**Monks Orchard Residents' Association  
Planning**

**Your Case Ref: CAS-163554**

**Stage 2 Complaint – Planning Approval Ref: 19/04705/FUL; 16-18 Ash Tree Close Croydon CR0 7SR**

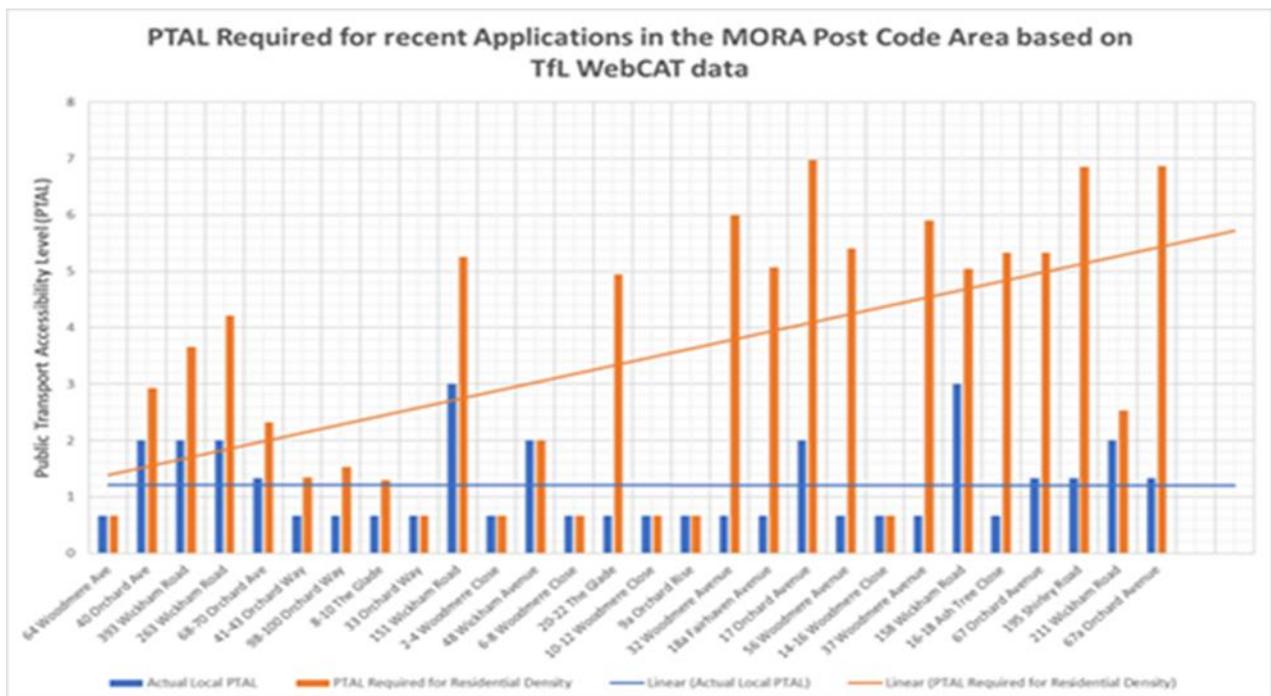
The fact that **ingress** and **egress** from **parking bays** require **manoeuvres necessitating mounting the footpath** and **encroaching** on other **dwellings’ forecourts** in **breach** of the **Highways Act - Section 27** are ample evidence that the site area **cannot cope** with the requirements of the development. The site area is **insufficient** to cater for all requirements. **(It is noted that you have failed to adequately respond to this issue raised in our Stage 1 Complaint)**. (See Appendix C – Parking Provision and Manoeuvres).

TfL WebCAT & London Plan Policy 3.4 illustrating appropriate Densities for a suburban Setting at PTAL 1a (**Blue Text**) and the actual required PTAL for the densities at **299.63hr/ha** of the proposed development (**Red Text**).

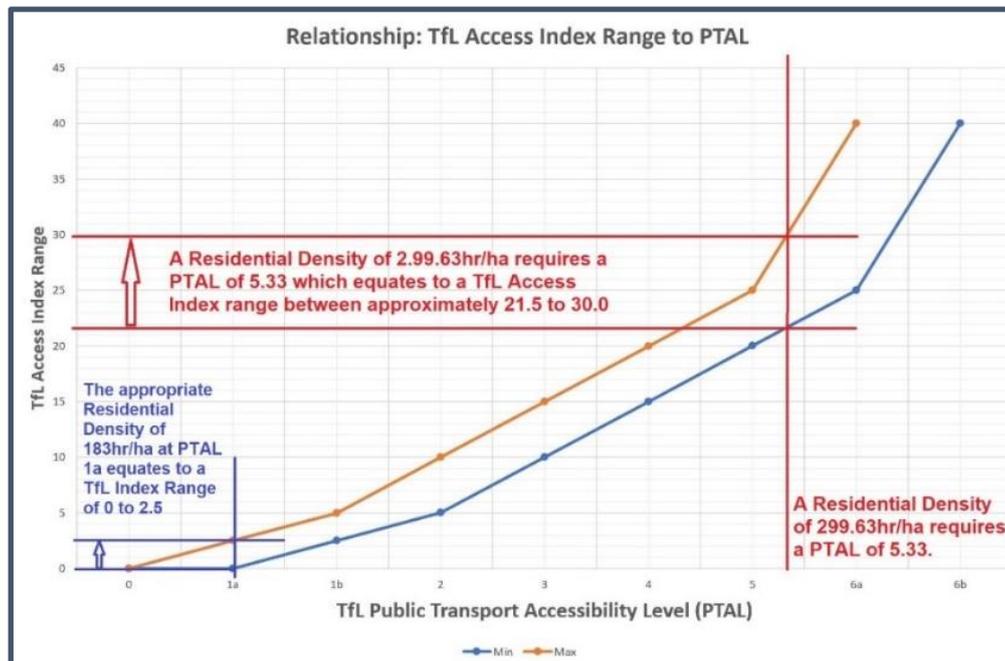
This Graph shows the conversion from **PTAL at 5.33** which requires a **TfL Access Index Range** between **≈21.5 to ≈30.0** for **Public Transport Accessibility** when the available Accessibility at **PTAL 1a** is actually between **0 and 2.5** for the localities **Public Transport Accessibility**.

We have analysed the current adopted **London Plan Policy 3.4** and devised the above basic **simple methodology and evaluation criterion** of the parameters defined in the current **London Plan Policy 3.4** which we have used to provide a **simple assessment** of the **appropriate densities** as **guidance of acceptability** or otherwise **for the proposed development**. Thus, without any **significant justifiable reasons to deviate** from these **calculated densities**, the proposals for this locality at **PTAL 1a** in a **Suburban Setting** should approximate to a **Residential Density of ≈183hr/ha** (within the “*broad*” Range 150 to 200 hr/ha) and a **Housing Density of ≈48.2units/ha** ( within the “*broad*” range of 35 to 55 units /ha) for **Sustainable Public Transport Accessibility**. Any deviation from these calculated figures **should be clearly justified by the Case Officer**.

### Plot 2 Parking Bay Egress

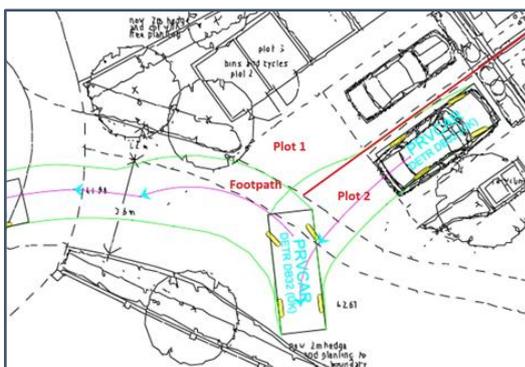
The Swept path diagram for Parking Bay **Plot 2** indicates the difficulty exiting the parking bay in reverse gear in order to exit the driveway in a forward gear into Ash Tree Close roadway.

The new swept path diagram shows that it is necessary to encroach over the curtilage of **Plot 1** Forecourt and then necessary to change into a forward gear and mount the access footpath in front of **Plot 1** in order to exit in a forward gear into Ash Tree Close.

maintenance which would prevent further manoeuvres of egress of a forward parked vehicle from exiting **Plot 2** Parking Bay.

### Plot 3 Parking Bay Egress

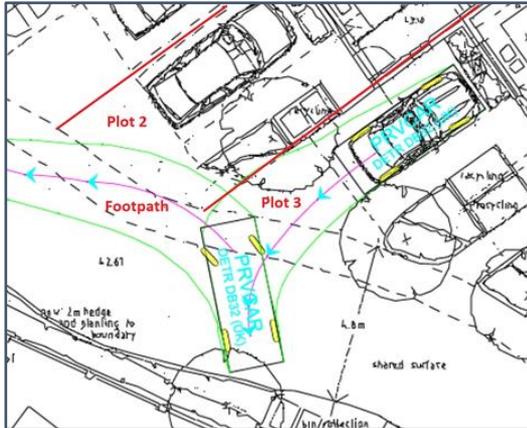
The Swept path diagram for Parking Bay **Plot 3** indicates the difficulty exiting parking bay in reverse gear in order to exit the driveway in a forward gear into Ash Tree Close.

The new swept path diagram shows that it is necessary to encroach over the curtilage of **Plot 2** Forecourt and then necessary to change into a forward gear and mount the access footpath in front of **Plot 2** in order to exit in a forward gear into Ash Tree Close.

The owner occupier of **Plot 2** may wish to erect a boundary fence to extend to the footpath in order to define their curtilage of responsibility and maintenance which would prevent further manoeuvres of egress of a forward parked vehicle from exiting **Plot 3** Parking Bay.

### Plot 6 Parking Bay Egress

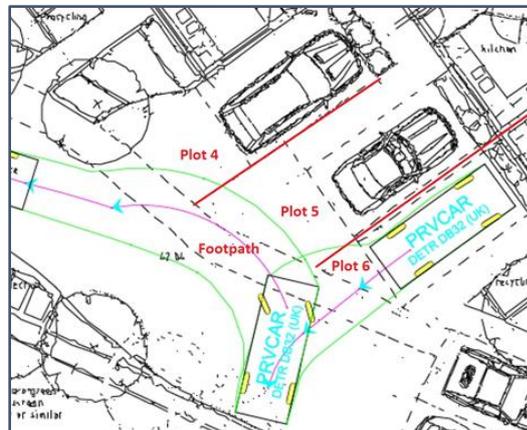
The Swept path diagram for Parking Bay for **Plot 6** indicates the difficulty exiting parking bay in reverse

gear in order to exit the driveway in a forward gear into Ash Tree Close roadway. The new swept path diagram shows that it is necessary to encroach over the curtilage of **Plot 4 & 5** Forecourt and mount the access footpath in front of **Plot 4 & 5** in order to exit in a forward gear into Ash Tree Close. The future occupants of **Plots 4 & 5** would likely object to this necessary manoeuvre for the life of the development as an inconvenience which could cause conflict for the life of the development.

maintenance which would prevent further manoeuvres of egress of a forward parked vehicle from exiting **Plot 6** Parking Bay.

### Plot 7 Parking Bay Egress

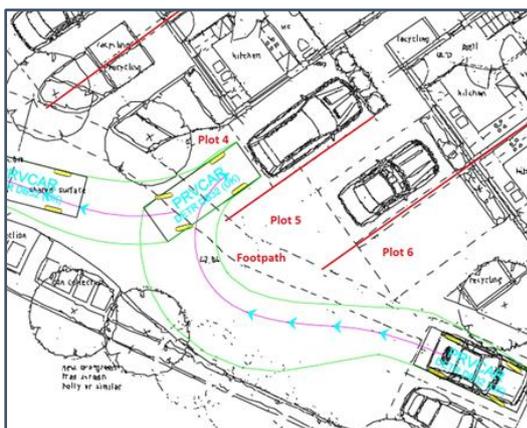
The Swept path diagram for Parking Bay **Plot 7** indicates the difficulty exiting parking bay in reverse gear in order to exit the driveway in a forward gear into Ash Tree Close roadway. The new swept path diagram shows that it is necessary to mount the footpath and encroach into the forecourt within the curtilage of **Plot 4** in a reverse gear before engaging a forward gear, mounting the access footpath in front of **Plot 4** in order to exit in a forward gear into Ash Tree Close.

The future occupants of **Plot 4** would likely object to this necessary manoeuvre for the life of the development as an inconvenience which could cause conflict for the life of the development.

### Plot 8 Parking Bay Egress

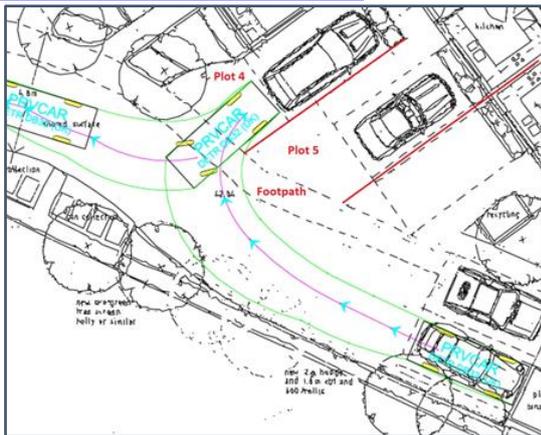
The Swept path diagram for Parking Bay **Plot 8** indicates the difficulty exiting parking bay in reverse gear in order to exit the driveway in a forward gear into Ash Tree Close roadway.

The new swept path diagram shows that it is necessary to mount the footpath and encroach into the forecourt within the curtilage of **Plot 4** in a reverse gear before engaging a forward gear, mounting the access footpath in front of **Plot 4** in order to exit in a forward gear into Ash Tree Close.
